## Fort Wayne Citilink CITS RFP Questions

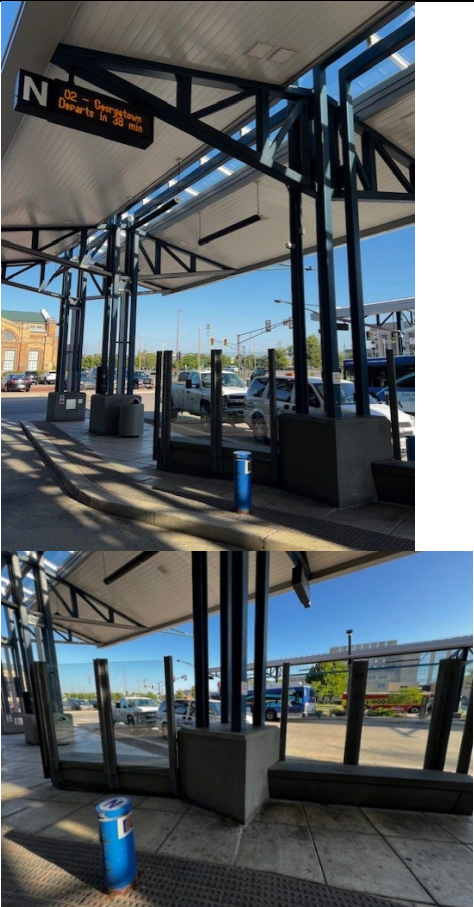
3.2.4 Tabular Display and Data Collection	<p>“CITS shall record the following service changes, update the display of bus service status, and adjust AVA announcements.</p> <ul style="list-style-type: none"> <li>• Bumps</li> <li>• Relays</li> <li>• Doubles”</li> </ul> <p>Q: Please explain, by way of example, what the above service change items are.</p>	<p>A Bump occurs when a bus has a breakdown at a layover. The operator of the broken down bus uses a follower bus (bus for the next trip on the run) to depart from the layover at the proper time for the broken down bus. The process of bumps continues for subsequent buses until a replacement bus arrives to replace the broken down bus.</p> <p>A Relay occurs when a new bus is inserted because the original bus is running significantly late. The new bus is inserted so it maintains the schedule of the original bus. When the new bus passes the original bus going in the opposite direction, the buses stop, and the bus operator from the original</p>

<p>bus takes over the new bus. The operator from the new bus completes the run for the original run and returns the original bus to the yard.</p> <p>A Double is a bus that is added to immediately follow a bus that is full. This allows the full bus to only offload passengers and regain schedule adherence.</p>
